## M-1980-244 TR-129 Points of Compliance - Numeric Protection Levels Second Adequacy Response

**RE: Permit No. M-1980-244; Cripple Creek & Victor Gold Mining Company; Cresson Project;** Second Adequacy Review Response; Technical Revision 129 (TR-129) Proposed Numeric Protection Levels and Site Point of Compliance Well Identification, Permit No. M-1980-244

Figure 2a

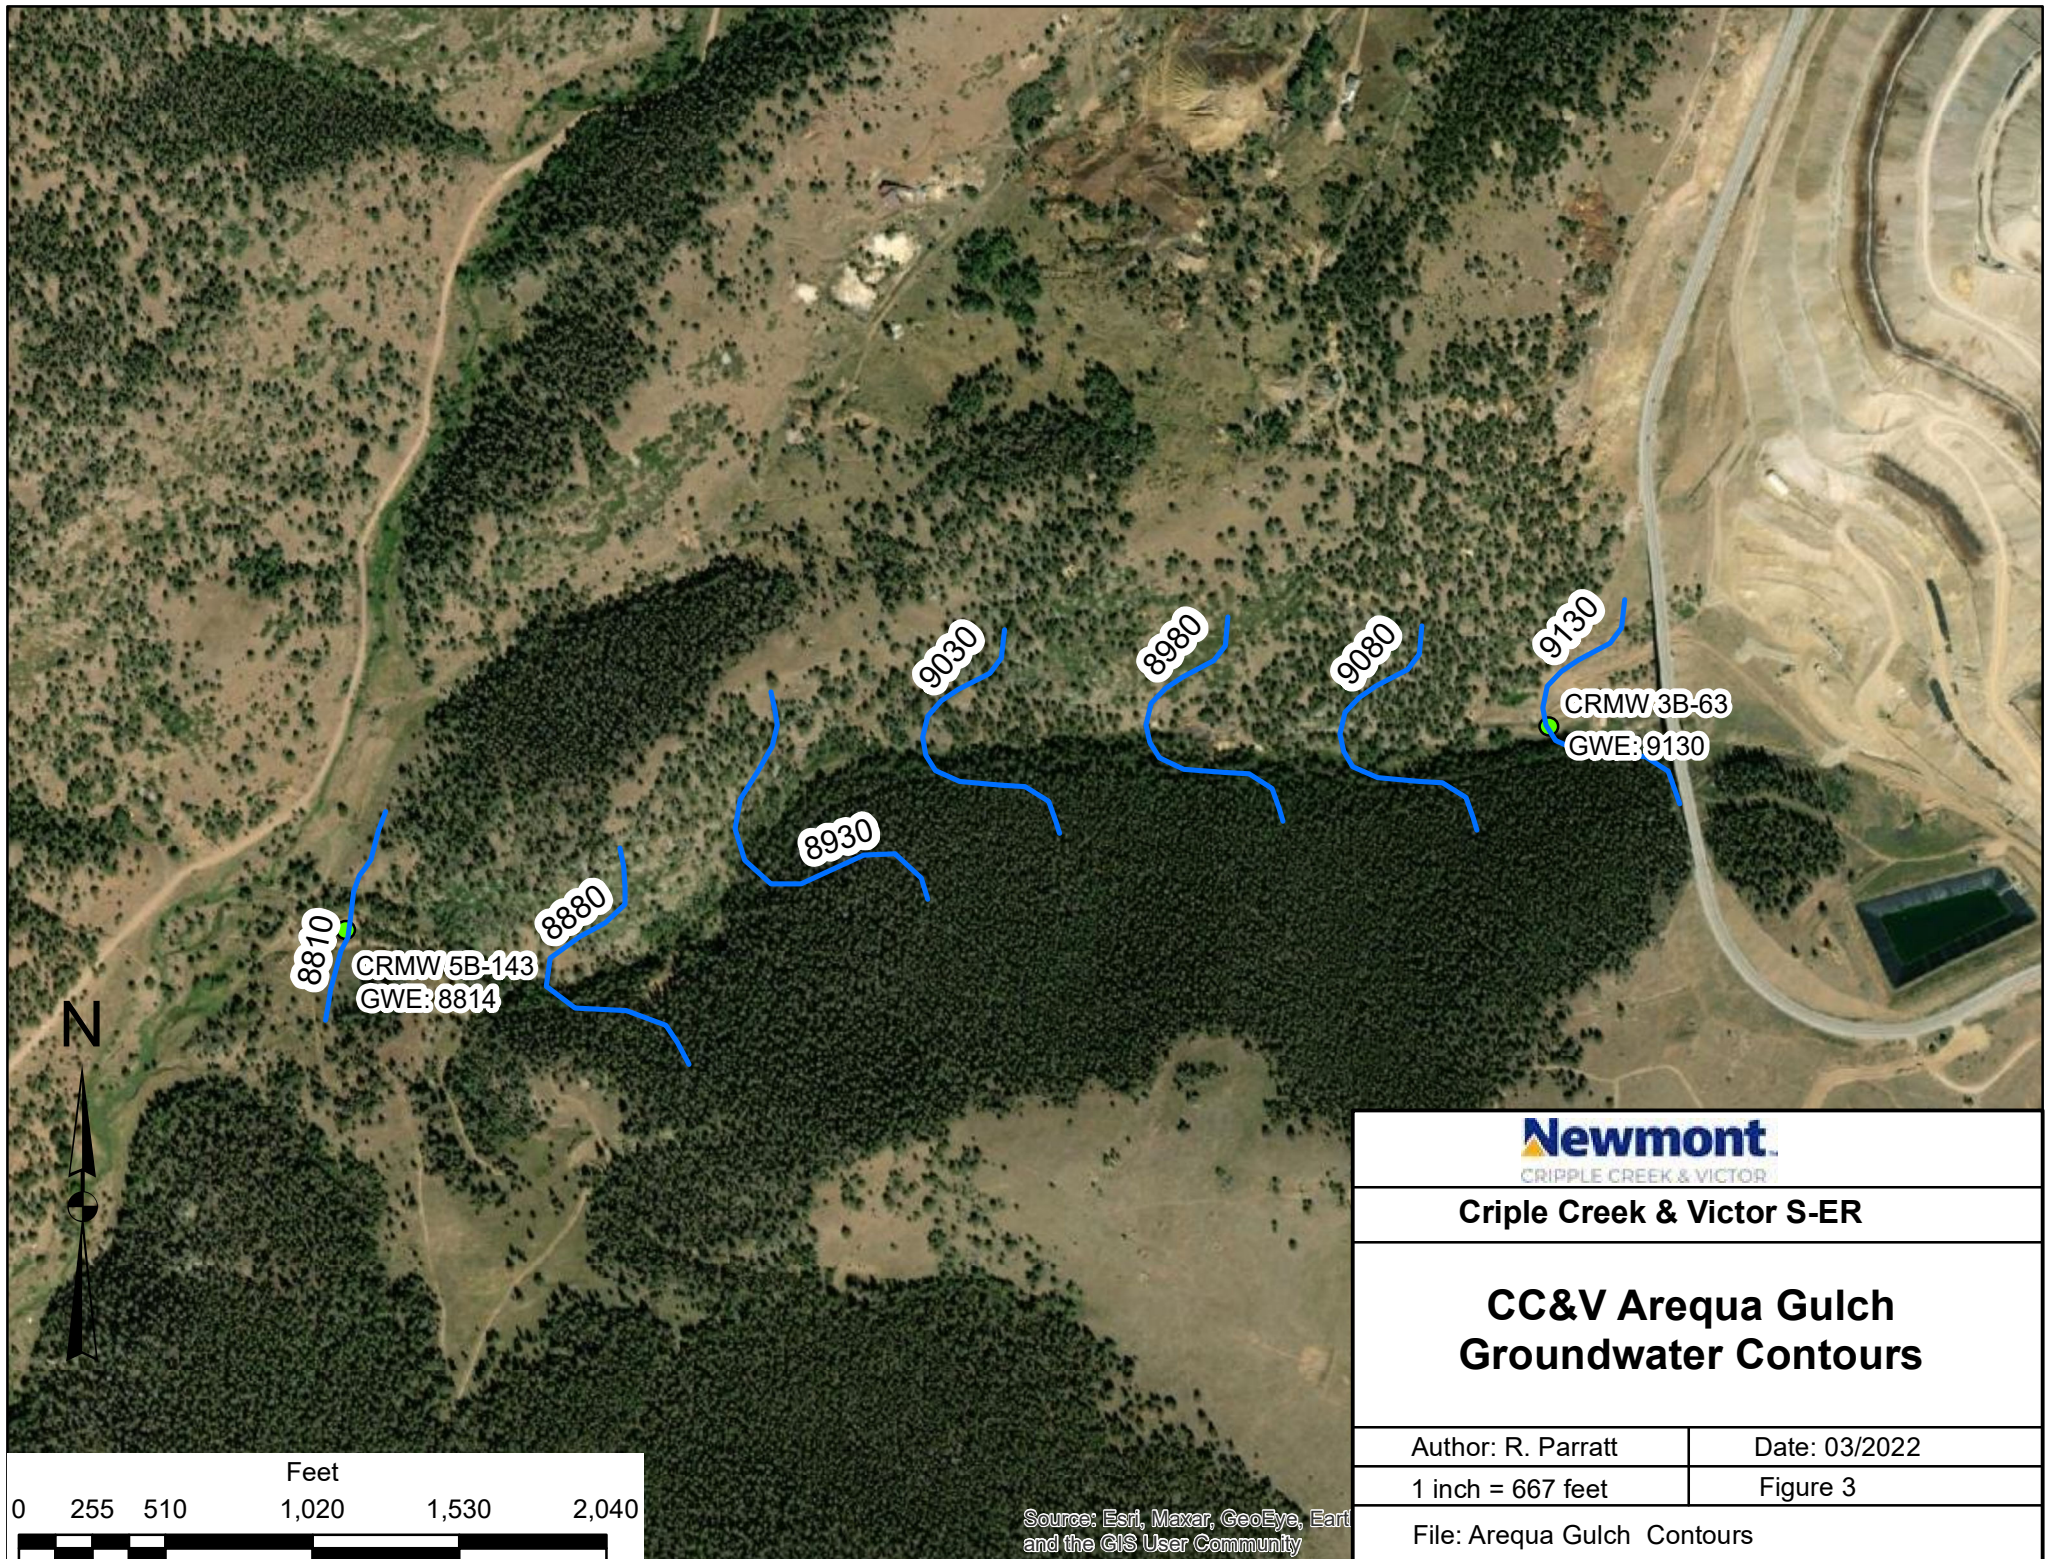
*Figure 2 needs to be revised to show the potentiometric surface of the alluvial water bearing zone on one figure, and the deeper bedrock aquifer on another figure.*

*On all figures please indicate what the water elevation is at each well that is used to generate the contour map.*

**Please see Attachment B for Grassy Valley deeper bedrock aquifer, and updated figures with elevations at each well that were used to generate the contour map.**

**Please see Attachment B for requested additional, and updated figures with elevations at each well that were used to generate the contour map.**

## Attachment C - Piper Diagrams

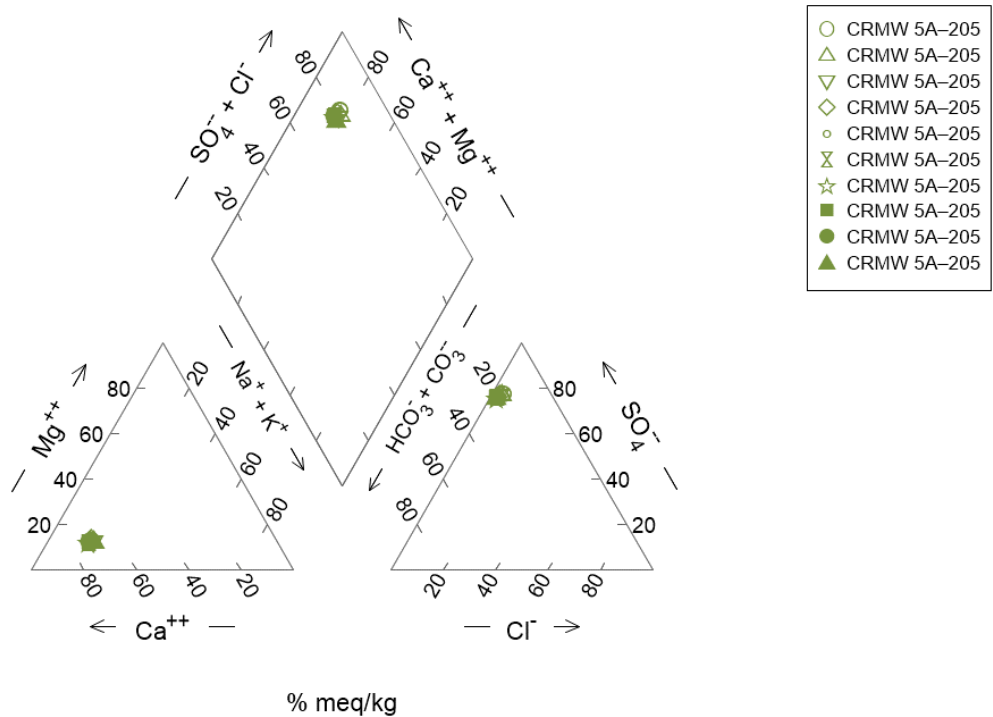
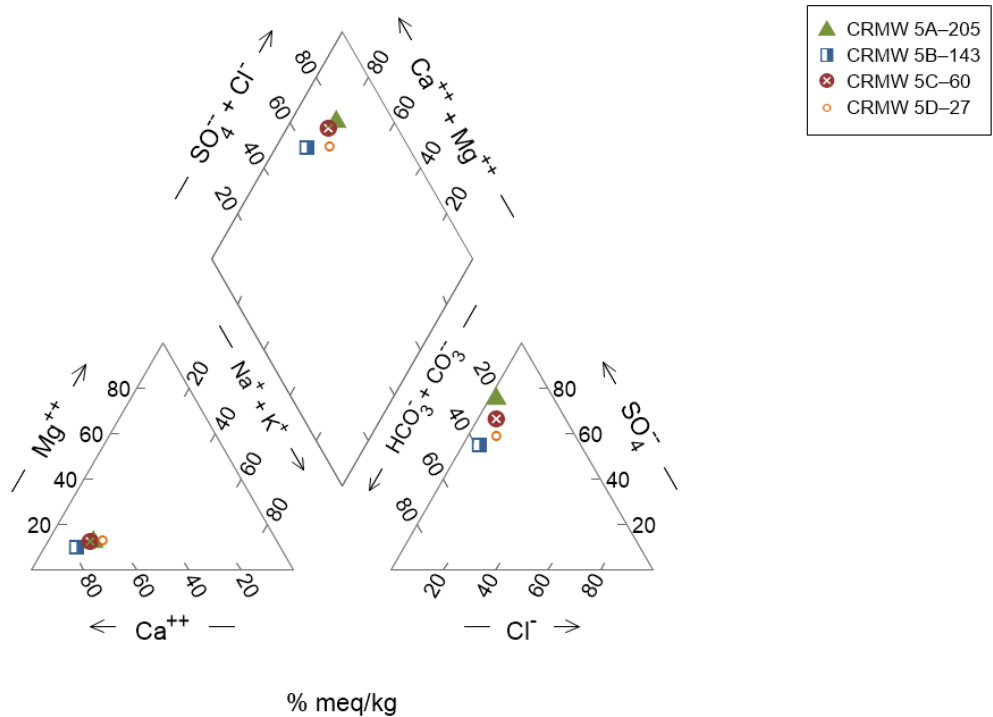
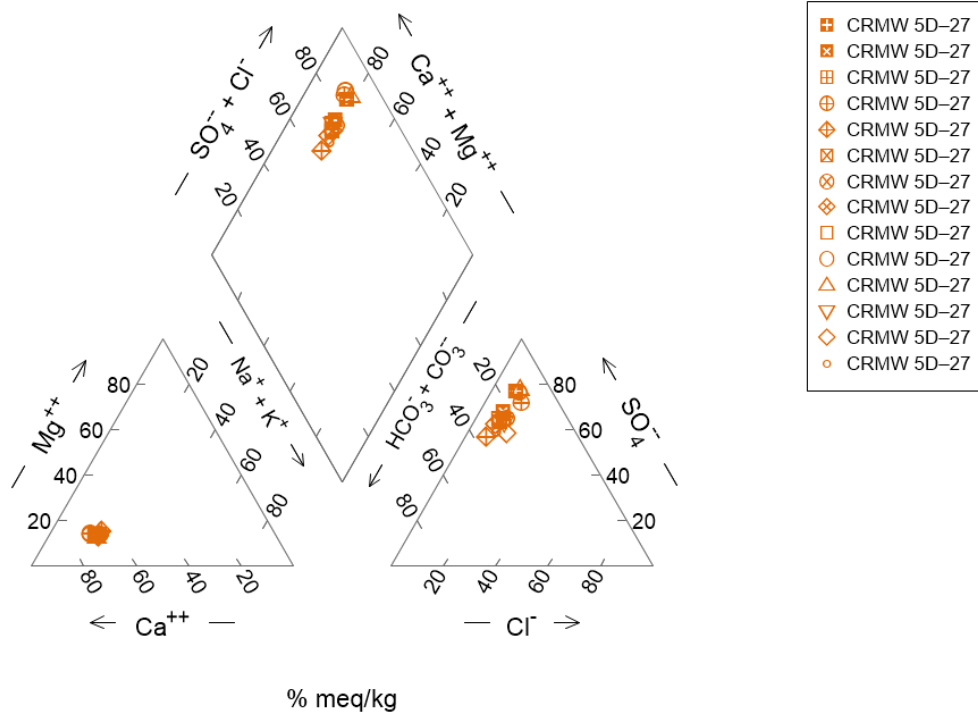
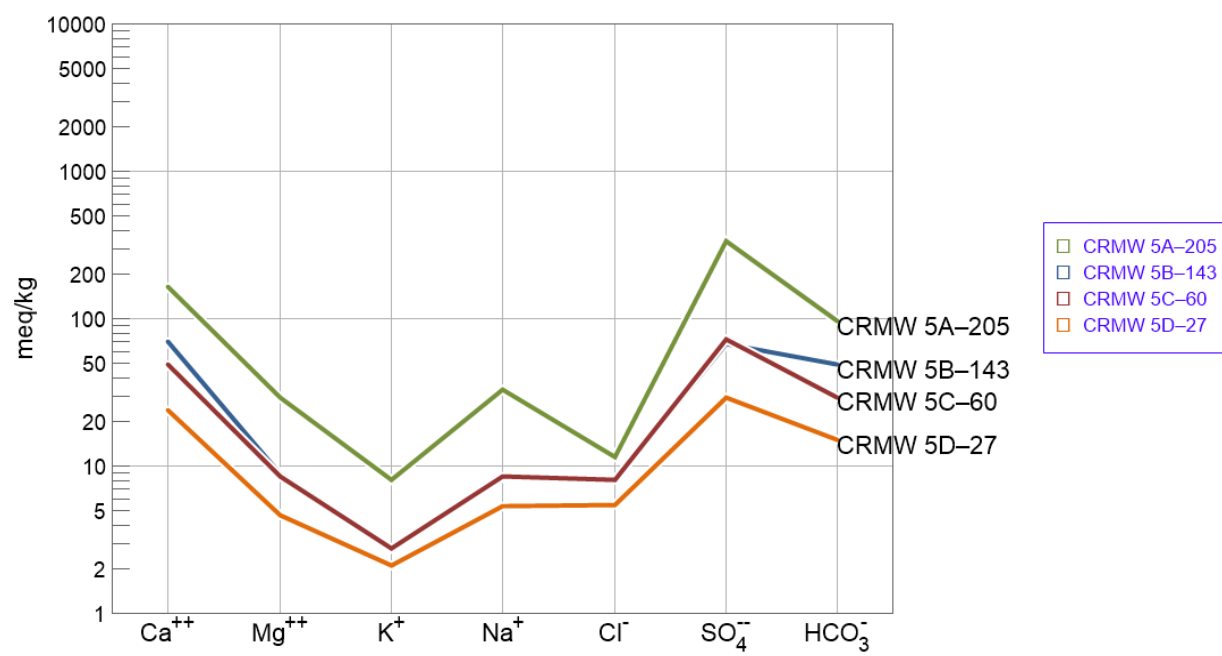
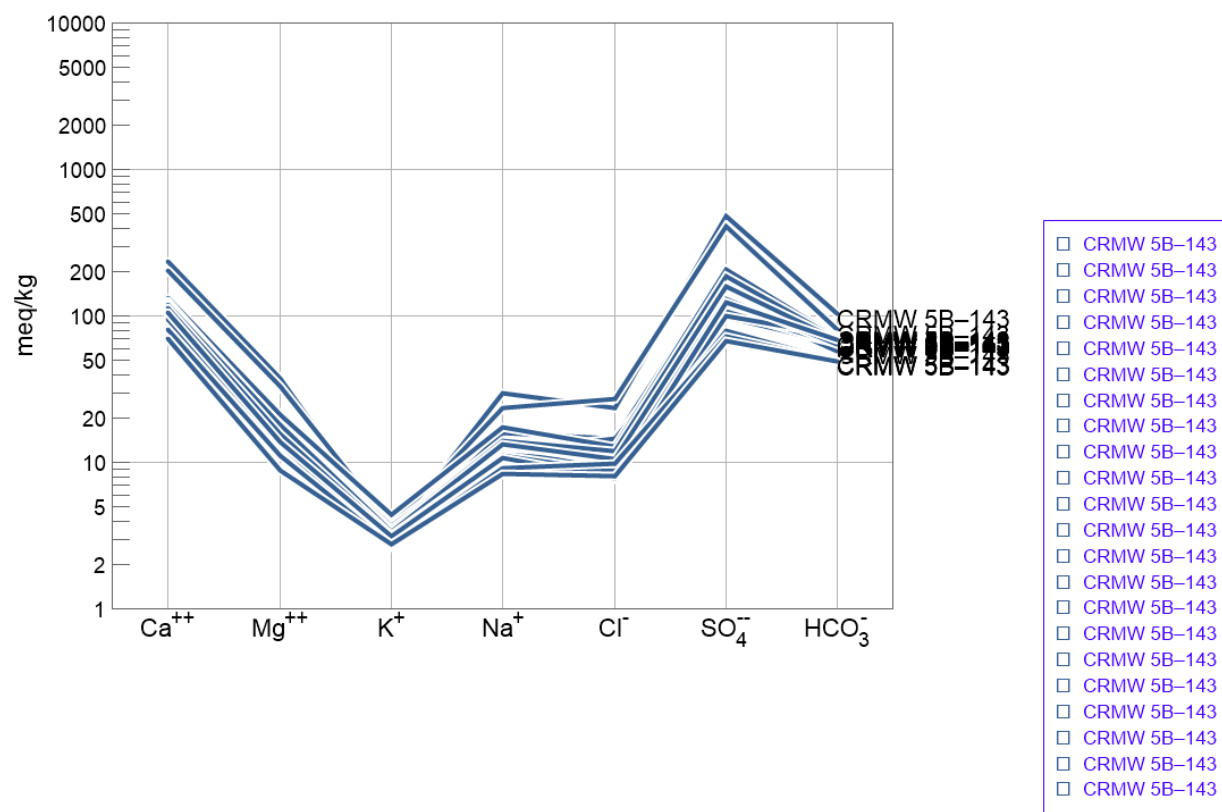
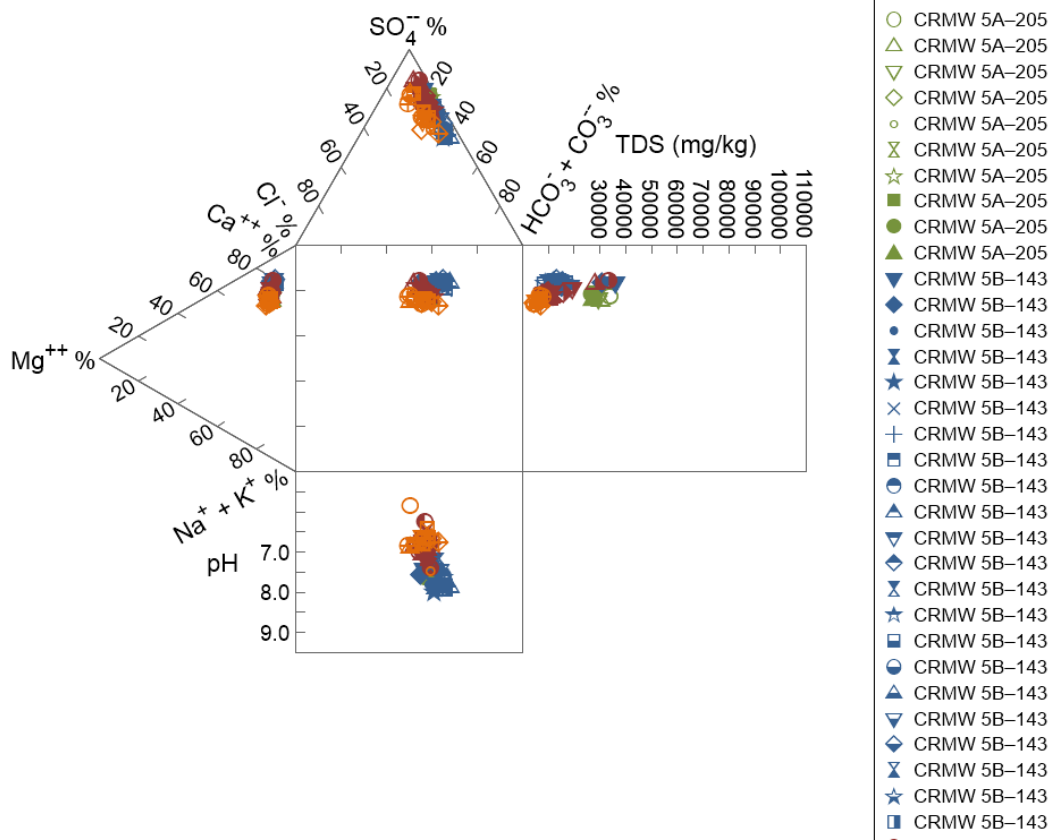
6. *(Follow up to Adequacy response received 2-10-2022, question #6) Groundwater at the site has been separated into a shallow, deep and deeper water bearing intervals, e.g., CRMW-5A, -5B, -5C, and -5D. All intervals need to have a point of compliance identified within each basin. Identify the additional points of compliance for Arequa Gulch, Grassy Valley, Vindicator Valley and Wilson Creek. At this time, Basins that do not currently have multiple groundwater intervals identified additional points of compliance do not to be identified.*

**Contained in Attachment C, CC&V is providing the water analysis (piper diagrams) completed for monitoring wells within Arequa Gulch (CRMW-5A, CRMW-5B, CRMW-5C, and CRMW-5D), Vindicator Valley (VIN-2A & VIN-2B) and Grassy Valley (GVMW-22A & GVMW-22B) as discussed during our May 3, 2022 meeting. Demonstrated in these data is that the Arequa Gulch monitoring wells are sampling the same water, as is the Vindicator Valley monitoring wells. Data analysis of the Grassy Valley monitoring wells indicate that there are differences between in the water sampled from the shallow and deep well. From this analysis CC&V is proposing**

**that the point of compliance for Arequa Gulch be the monitoring well CRMW-5B, and the point of compliance for Vindicator be the monitoring well VIN-2B.**
